UNITED STATES PATENT AND TRADEMARK OFFICE

APPLICATION NO.	FILING DATE	FIRST NAMED INVENTOR	ATTORNEY DOCKET NO.	CONFIRMATION NO.
10/577,463	09/28/2006	Jyrki Kauppinen	1028443-000073	5051
21839 7590 01/31/2008 BUCHANAN, INGERSOLL & ROONEY PC POST OFFICE BOX 1404 ALEXANDRIA, VA 22313-1404			EXAMINER SKOVHOLT, JONATHAN	
			ART UNIT 2877	PAPER NUMBER
			NOTIFICATION DATE 01/31/2008	DELIVERY MODE ELECTRONIC

Office Action Summary	Application No. 10/577,463	Applicant(s) KAUPPINEN, JYRKI	
	Examiner JONATHAN SKOVHOLT	Art Unit 2877

DETAILED ACTION

Fig. 1 from Tank et al. (US Patent 5,148,235).

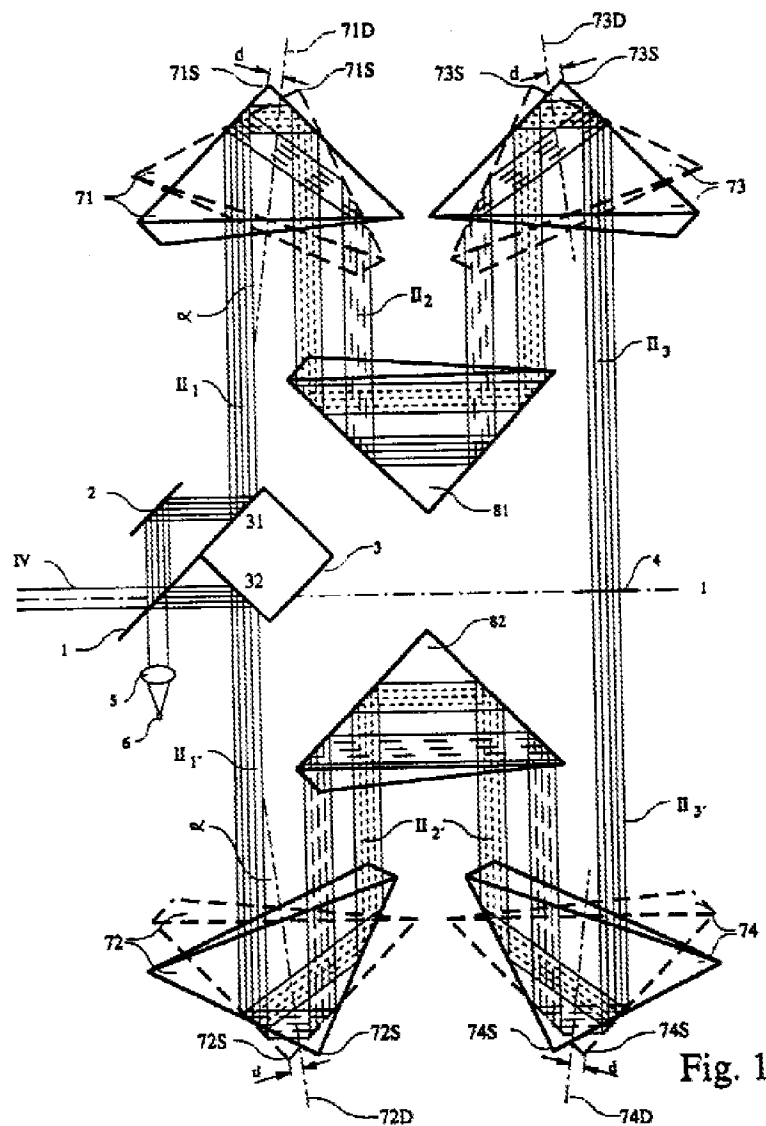
Regarding **claim 1**, Tank teaches an interferometer, comprising:

- a beamsplitter ((1) Fig. 1);
- at least one end reflector for returning beams (stationary retroreflectors (81) & (82) are the end reflectors); and

- a set of reflectors for reflecting the beams between the beamsplitter and the at least one end reflector (rotating retroreflectors ((71), (72), (73), and (74)),
- at least some of said set of reflectors being adapted to be rotatable around an axis (the rotating retroreflectors are adapted to be rotatable around an axis),
- said set of reflectors comprises two angle reflectors, constituted by plane reflectors (the rotating retroreflectors are angled and comprised of two plane reflectors), and wherein said at least one end reflector comprises an angle reflector constituted by plane reflectors (the stationary retroreflectors are angled and comprised of two plane reflectors), and that an angle line of the at least one end reflector is arranged perpendicular to an angle line of the two angle reflectors of the set of reflectors (see Fig. 1).

Regarding **claim 2**, Tank teaches all as applied to claim 1 above, in addition Tank teaches an interferometer wherein the angle reflector of the at least one end reflector is constituted by two plane reflectors, between which is provided an angle typically of about 72-107 degrees (the

angle between the two plane reflectors of the end reflectors (81) & (82) is within this range as is shown in Fig. 1).

Regarding **claim 4**, Tank teaches all as applied to claim 1 above, in addition Tank teaches an interferometer wherein, said set of reflectors further comprises at least one pair of plane reflectors (the set of reflectors (71), (72), (73), and (74) are each comprised of a pair of plane reflectors).

Regarding **claim 5**, Tank teaches all as applied to claim 4 above, in addition Tank teaches an interferometer wherein the pair of plane reflectors has its plane reflectors arranged in such a way that the beams, coming from the beamsplitter (2) to the pair of plane reflectors (the two sides of the retroreflectors (71), (73), or (74)), travel by way of at least one of the set of reflectors (retroreflectors (71), (73), or (74)) and hit the at least one end reflector (82) perpendicularly to the angle line of the at least one end reflector, the beams reflected from the at least one end reflector returning over the same direction but laterally shifted back to the beamsplitter (the outgoing beam that is reflected by retroreflector (82) will be parallel to the incoming beam and therefore the beam will return in the same direction however the incoming and outgoing beams are laterally shifted from one another) (see Fig. 1).

Regarding **claim 6**, Tank teaches all as applied to claim 1 above, in addition Tank teaches an interferometer wherein the interferometer is arranged in such a way that a beam to be delivered to the interferometer is conductible to the beamsplitter (2), the beamsplitter being arranged to divide the beam into two beams, namely a first beam and a second beam, the first beam is arranged to be reflected from the beamsplitter to a first angle reflector (retroreflector (71)) and further towards the at least one end reflector (retroreflector (81)), and to return from

the at least one end reflector over the same direction but laterally shifted back to the beamsplitter (the outgoing beam that is reflected by retroreflector (81) will be parallel to the incoming beam and therefore the beam will return in the same direction however the incoming and outgoing beams are laterally shifted from one another), the second beam is arranged to pass through the beamsplitter and to advance to a second angle reflector (retroreflector (72)) and further towards the at least one end reflector (retroreflector (82)), and to return over the same direction but laterally shifted back to the beamsplitter (the outgoing beam that is reflected by retroreflector (82) will be parallel to the incoming beam and therefore the beam will return in the same direction however the incoming and outgoing beams are laterally shifted from one another), and that the beamsplitter is arranged to combine the first and second beams returning from the at least one end reflector for a single beam (the beamsplitter combines the beams after being reflected by the retroreflectors) (see Fig. 1).

Regarding **claim 7**, Tank teaches all as applied to claim 4 above, in addition Tank teaches an interferometer wherein the interferometer is arranged in such a way that a beam to be delivered to the interferometer is conductible to the beamsplitter (2), the beamsplitter being arranged to divide the beam into two beams, namely a first beam and a second beam, the first beam is arranged to be reflected from the beamsplitter to a first plane reflector (one of the reflective sides of retroreflector (71)), from the first plane reflector to the first angle reflector (retroreflector (71)), from a first angle reflector towards the at least one end reflector (retroreflector (81)), and to return from the at least one end reflector over same direction but laterally shifted (the outgoing beam that is reflected by retroreflector (81) will be parallel to the incoming beam and therefore the beam will return in the same direction however the incoming

and outgoing beams are laterally shifted from one another) back to the beamsplitter, the second beam is arranged to pass through the beamsplitter and to advance to a second plane reflector (one of the reflective sides of retroreflector (72)) and to reflect from the second plane reflector to a second angle reflector (retroreflector (72), from the second angle reflector towards the at least one end reflector (retroreflector (82)), and to return from the at least one end reflector over the same direction but laterally shifted back to the beamsplitter (retroreflector (82)), and to return over the same direction but laterally shifted back to the beamsplitter (the outgoing beam that is reflected by retroreflector (82) will be parallel to the incoming beam and therefore the beam will return in the same direction however the incoming and outgoing beams are laterally shifted from one another), the beamsplitter is arranged to combine the first and the second beams returning from the at least one end reflector for a single beam (the beamsplitter combines the beams after being reflected by the retroreflectors) (see Fig. 1).

Regarding **claim 10**, Tank teaches a method in an interferometer, wherein optical beams are guided using at least two angle reflectors (rotating retroreflectors ((71), (72), (73), and (74)), constituted by plane reflectors (the retroreflectors are made of two plane reflectors), and at least one end reflector constituted by plane reflectors (stationary retroreflectors (81) & (82) are the end reflectors, which are made of two plane reflectors), and wherein an angle line of the at least one end reflector is arranged perpendicular to an angle line the two reflectors of the set of reflectors (see Fig. 1).

- at least a beamsplitter ((1) Fig. 1);
- at least one end reflector for returning beams (stationary retroreflectors (81) & (82) are the end reflectors); and

- a set of reflectors for reflecting the beams between the beamsplitter and the at least one end reflector (rotating retroreflectors ((71), (72), (73), and (74)), at least some of said set of reflectors being adapted to be rotatable around an axis (the rotating retroreflectors are adapted to be rotatable around an axis), said set of reflectors comprises two angle reflectors retroreflectors, constituted by plane reflectors ((71), (72), (73), and (74) are angle reflectors that have two plane reflectors associated with each retroreflector), and said at least one end reflector is an angle reflector constituted by plane reflectors (the stationary retroreflectors are angled and comprised of two plane reflectors), and an angle line of the at least

one end reflector is arranged perpendicular to an angle line of both of the angle reflectors (see Fig. 1).
